**STAFF REPORT AND RECOMMENDATION TO THE DESIGN COMMISSION**

**CASE FILE:** LU 14-169513 DZM AD & Major Encroachment Review (PC # 13-173133 & DA #13-186674) 419 E Burnside  
**REVIEW BY:** Design Commission  
**WHEN:** September 4, 2014 @ 1:30pm  
**WHERE:** 1900 SW Fourth Ave., Room 2500A Portland, OR 97201

**Proposal:**  
The applicant proposes a new 6-story ¾-block mixed-use building with 153 residential units, 3 live/work units, ground floor commercial space, as well as shared and private rooftop terraces. The proposal includes an arcade along E. Burnside that includes living area above the public right-of-way. Parking is provided within the building for 81 vehicles, including 17 tandem spaces, to be accessed from NE Grand Avenue, with 2 loading spaces accessed from NE Couch Street. Exterior materials include cast-in-place concrete, metal panel, operable storefront systems, fiberglass doors, and vinyl windows. The existing 2-story building at the northwest corner of the block is proposed to remain.

Exterior Elevation - East

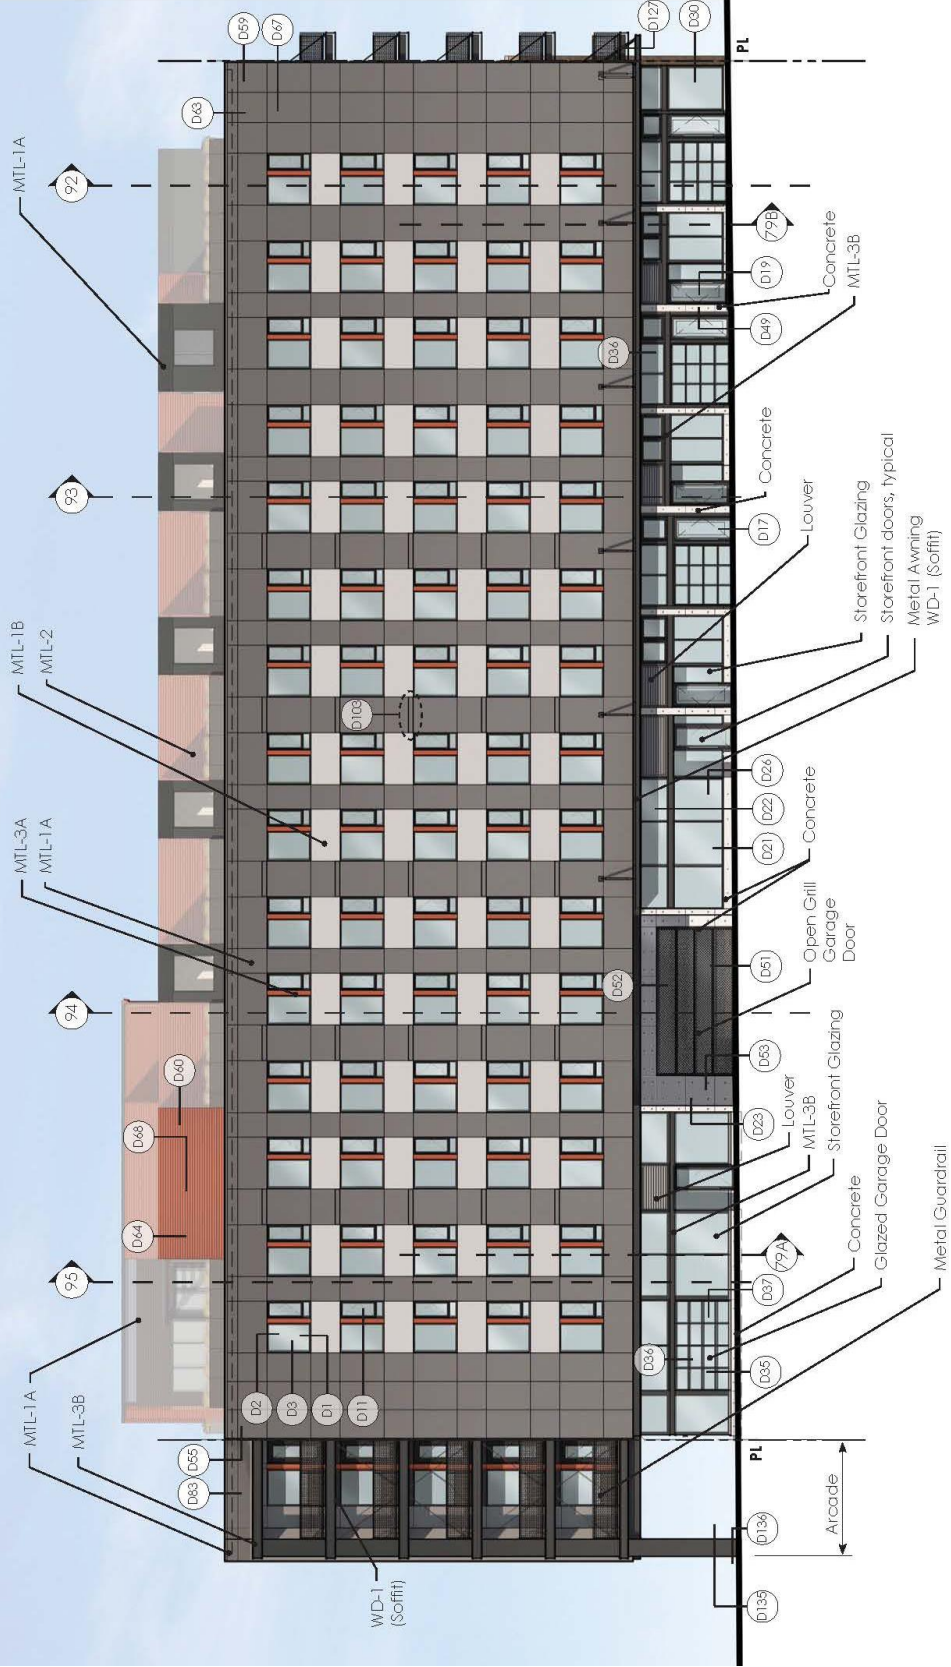
***This guideline is not yet met, however, with incorporation of additional recessed balconies on the Grand Avenue façade, this guideline could be met.***

**Windows.** Grand Avenue needs additional articulation to mitigate for the flatness of the façade. Staff suggests additional recessed balconies arranged in an orderly manner, as well as additional layering in the window bays. Staff notes that the section details, on pages 108 and 109, show that the light gray spandrel panels and red break metal mullions are shown to be in the same plane, recessed 1” behind the dark gray primary metal cladding, with the window recessed an additional 5”. Staff believes that additional recessing of the windows would help strengthen the layering and texture of the building volumes and reduce the overall flatness which is most apparent on the Grand Avenue façade.

Exterior Elevation - North

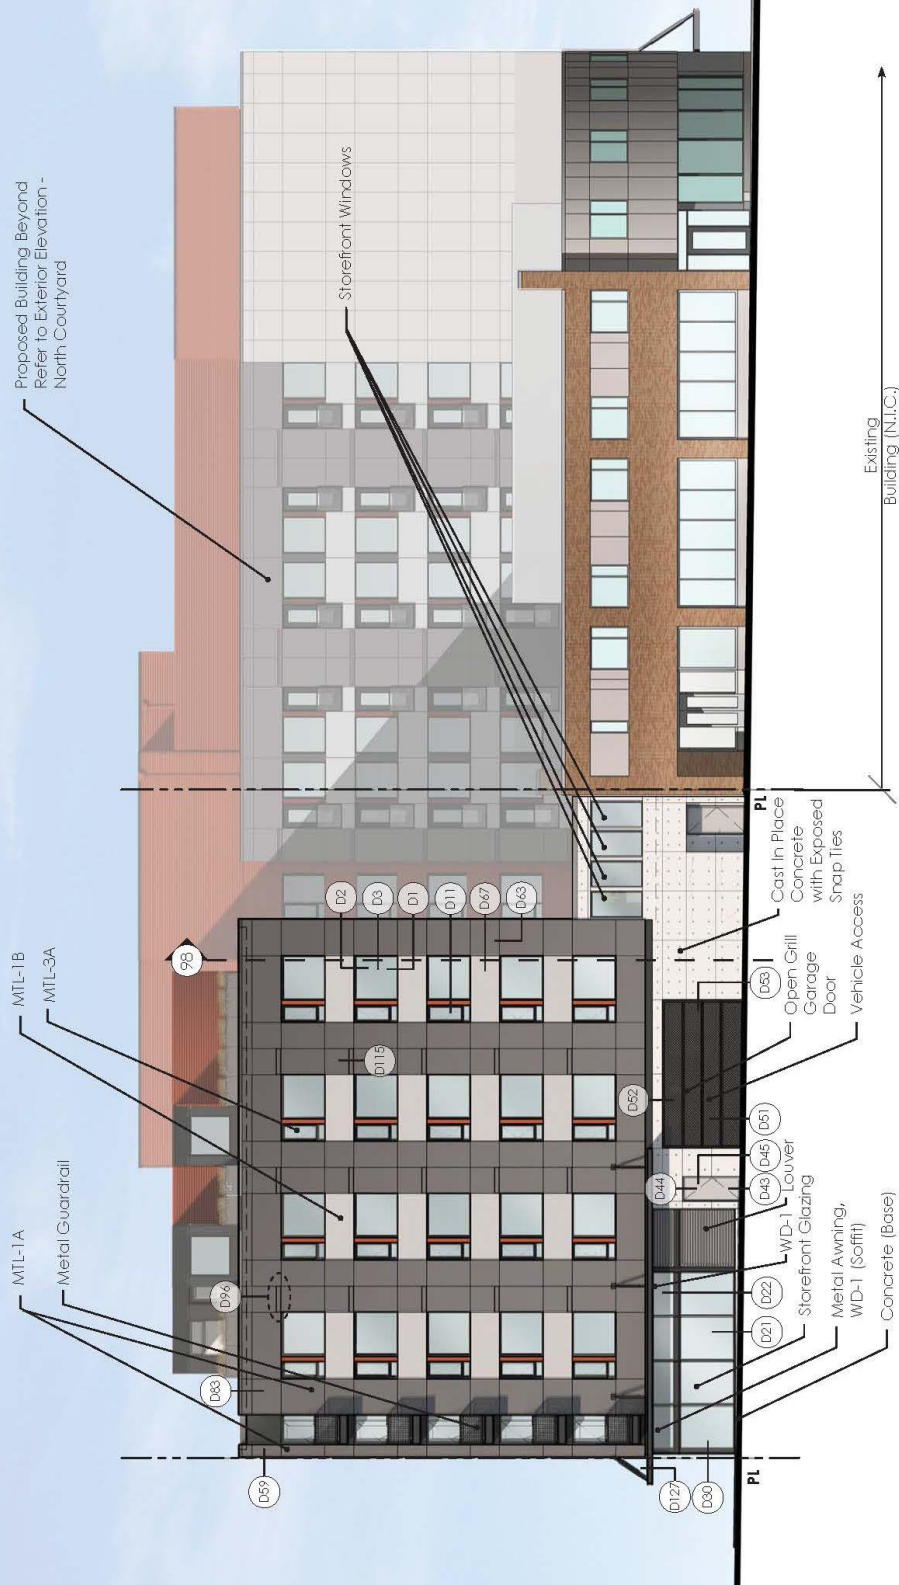
**Findings:** When considered across the entire frontage of the length of the site along NE Couch, the total amount of ground floor windows exceeds the 50% required. However, when considering only the project area, windows account for only 25% of the total length of the Couch frontage. The applicant is seeking a lot confirmation to sever the two lots at the northwest corner of the block, occupied by the Central City Concern building, which would ultimately result in a non-conforming situation with regard to the individual proposed building except for this Modification. The applicant has indicated that the proposed concrete wall

Since opportunities at the ground level are limited, staff suggests that improvements to the 2<sup>nd</sup> level, where an enclosed terrace is proposed, may help to alleviate the fortress-like quality of this ground level façade. In addition, as noted above, the loading door and an egress door are currently designed to be flush with the concrete wall and should be slightly recessed. If possible, considering the shear requirements, this may help provide additional layering to the ground level on this frontage.

***Staff does not yet believe that this Modification merits approval; however with minor revisions to the layering of the loading and egress doors and the 2<sup>nd</sup> floor terrace façade, this Modification could merit approval.***
